A d d e n d u m

Iowa Department of Transportation
Office of Contracts

B.O.	Proposal ID	Proposal Work Type	County	Project Number	Addendum
110	97-0121-031	PCC SIDEWALK/TRAIL	WOODBURY	NHSN-012-1(31)--2R-97	17JUN110.A01

SHEET S.2

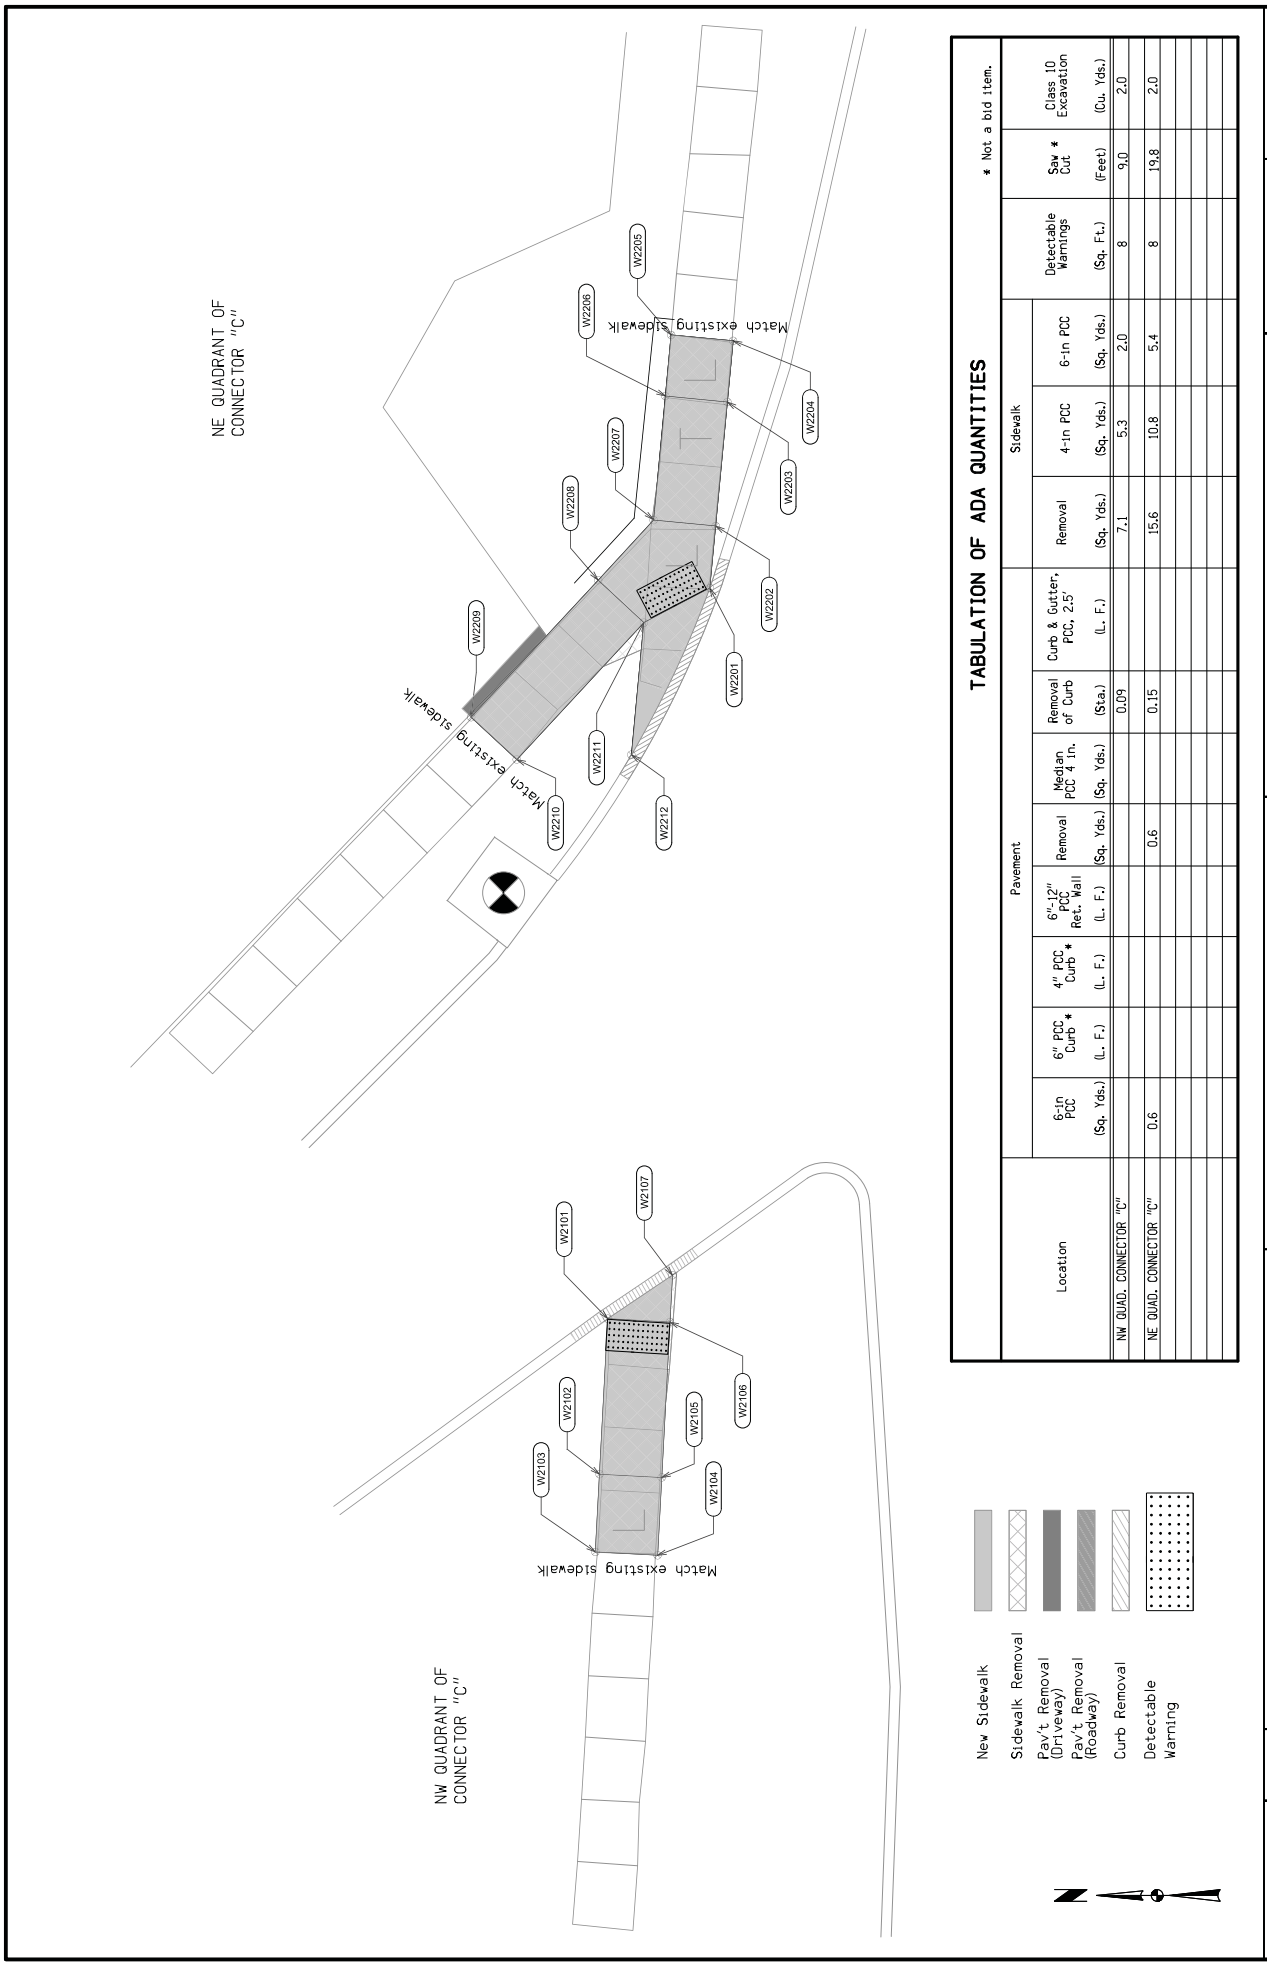
1. NE Quadrant of Connector "C", in the Pavement Section column for 6-in PCC (Sq. Yds.) add 0.6.

SHEET S.3

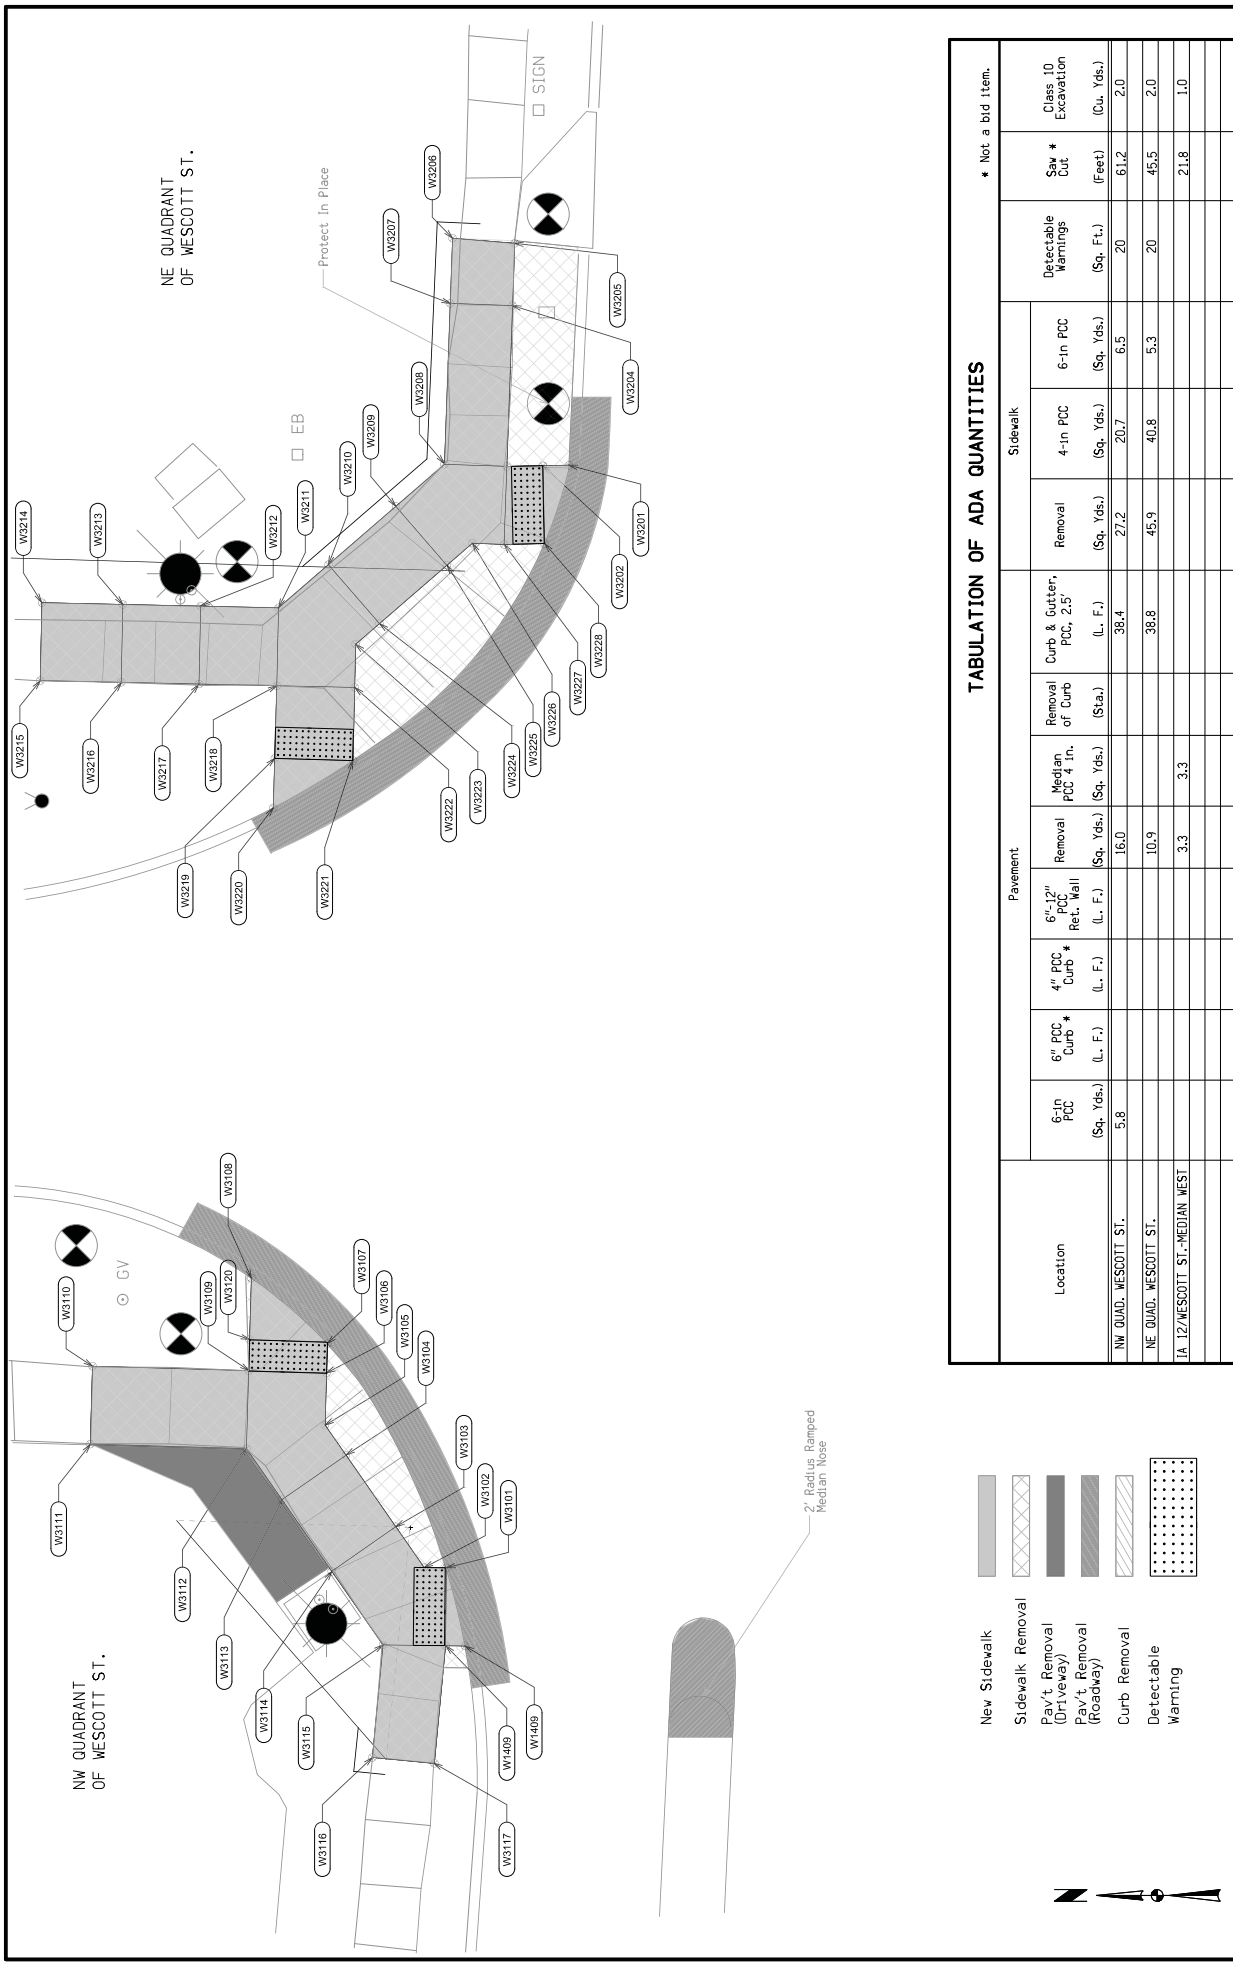
1. NW Quadrant of Wescott St., in the Pavement Section column for 6-in PCC (Sq. Yds.) add 5.8.
2. NW Quadrant of Wescott St., in the Pavement Section column for Removal revise number to 16.0 (from 5.8).
3. NW Quadrant of Wescott St., in the Sidewalk Section column for 4-in PCC (Sq. Yds.) revise number to 20.7 (from 16.1).
4. NE Quadrant of Wescott St., in the Pavement Section column for Removal (Sq. Yds.) add 10.9.
5. NE Quadrant of Wescott St., in the Sidewalk Section column for 4-in PCC (Sq. Yds.) revise number to 40.8 (from 25.8).

SHEET S.4

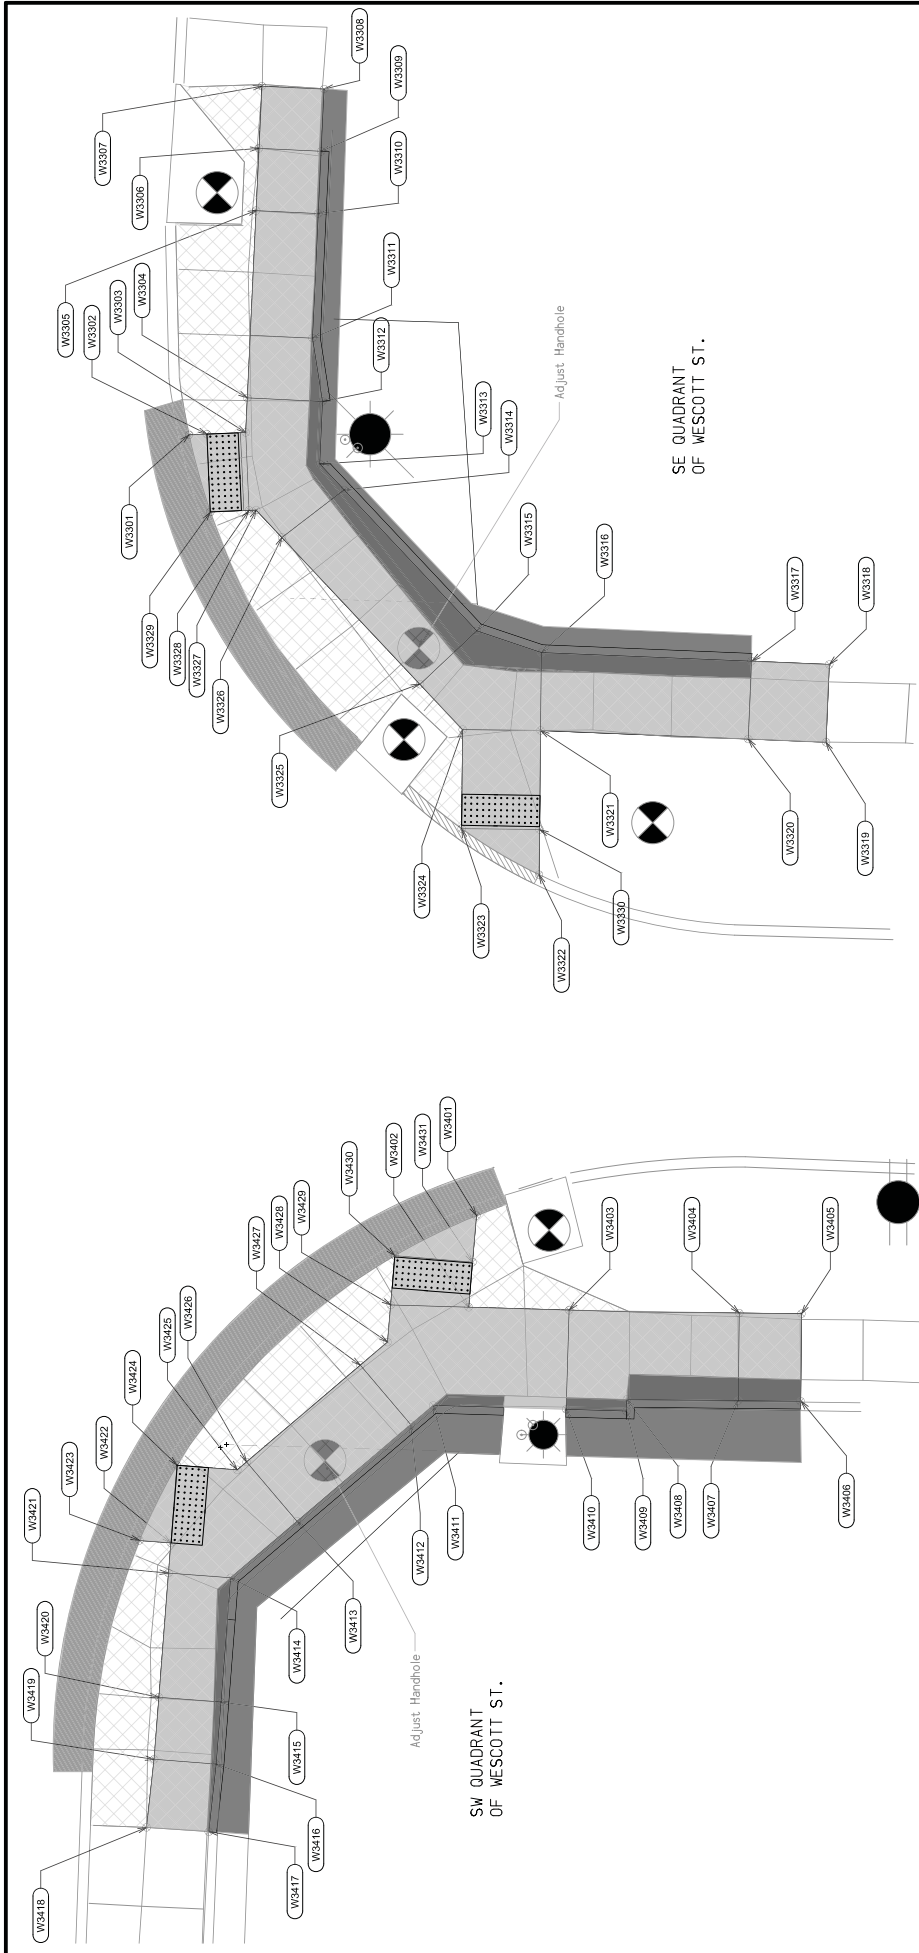
1. SW Quadrant of Wescott St., in the Pavement Section column for 6-in PCC (Sq. Yds.) add 13.0.
2. SW Quadrant of Wescott St., in the Pavement Section column for 6"- 12" PCC Ret. Wall (L.F.) add 27.4.

3. SW Quadrant of Wescott St., in the Pavement Section column for Removal (Sq. Yds.) revise number to 32.7 (from 19.3).
4. SW Quadrant of Wescott St., in the Sidewalk Section column for Removal (Sq. Yds.) revise number to 54.0 (from 52.8).

5. SW Quadrant of Wescott St., in the Sidewalk Section column for 4-in PCC (Sq. Yds.) revise number to 49.4 (from 30.4).
6. SW Quadrant of Wescott St., in the Pavement Section column for 6-IN PCC Curb (L.F.)* add 25.1.

7. SE Quadrant of Wescott St., in the Pavement Section column for Removal (Sq. Yds.) revise number to 22.4 (from 14.7).
8. SE Quadrant of Wescott St., in the Pavement Section column for 6-in PCC (Sq. Yds.) add 8.2.

9. SE Quadrant of Wescott St., in the Pavement Section column for 6"- 12" PCC Ret. Wall (L.F.) add 47.8.
10. SE Quadrant of Wescott St., in the Sidewalk Section column for 4-in PCC (Sq. Yds.) revise number to 60.5 (from 34.9).

11. SE Quadrant of Wescott St., in the Sidewalk Section column for Removal (Sq. Yds.) revise number to 54.0 (from 54.3).

SHEET S.5

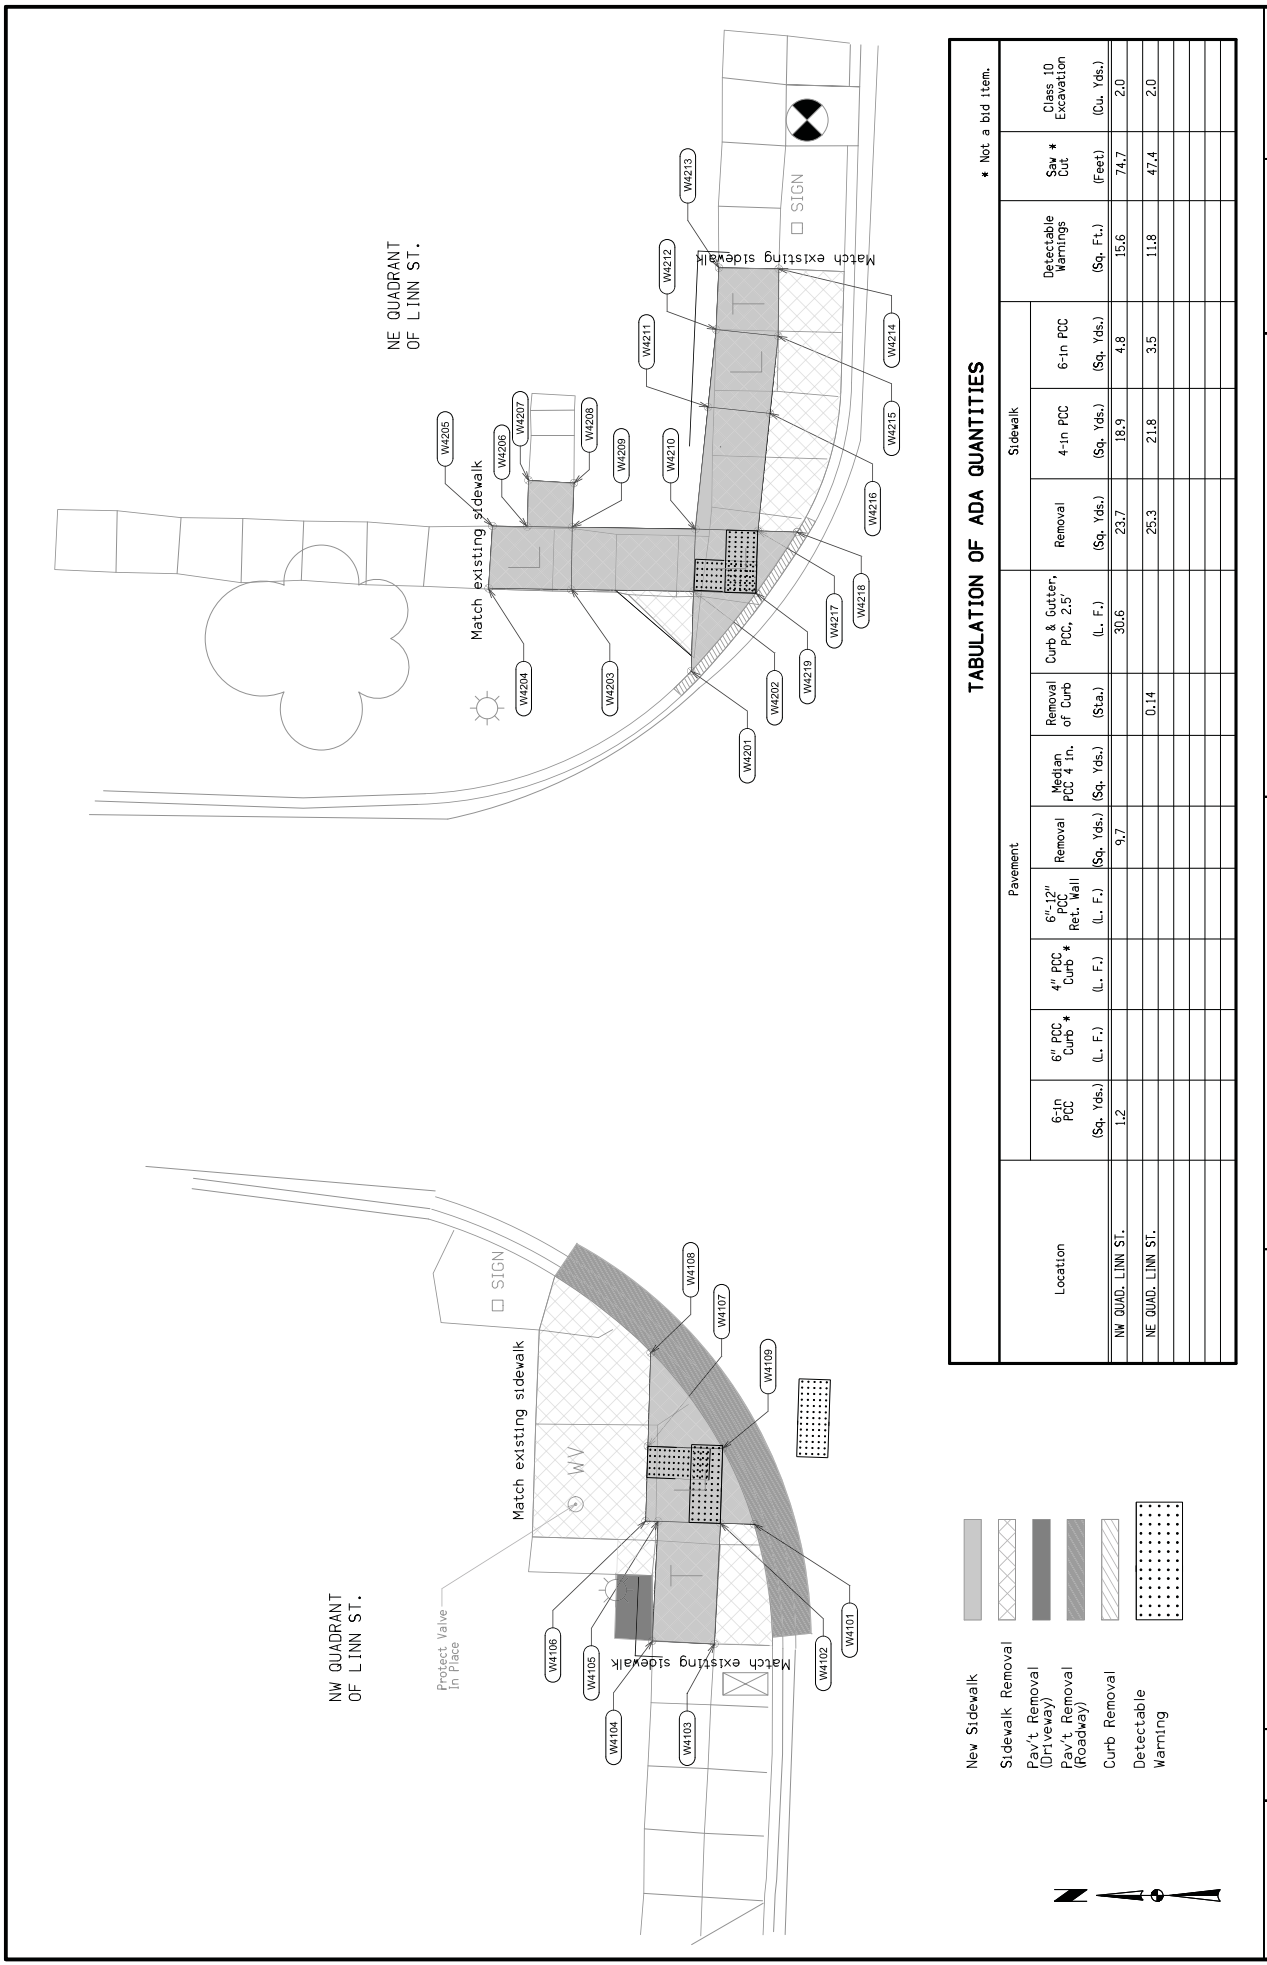
1. NW Quadrant of Linn St., in the Pavement Section column for 6-in PCC (Sq. Yds.) add 1.2.
2. NW Quadrant of Linn St., in the Pavement Section column for Removal (Sq. Yds.) revise number to 9.7 (from 1.09).
3. NW Quadrant of Linn St., in the Sidewalk Section column for 4-in PCC (Sq. Yds.) revise number to 18.9 (from 3.6).
4. NE Quadrant of Linn St., in the Sidewalk Section column for 4-in PCC (Sq. Yds.) revise number to 21.8 (from 14.2).
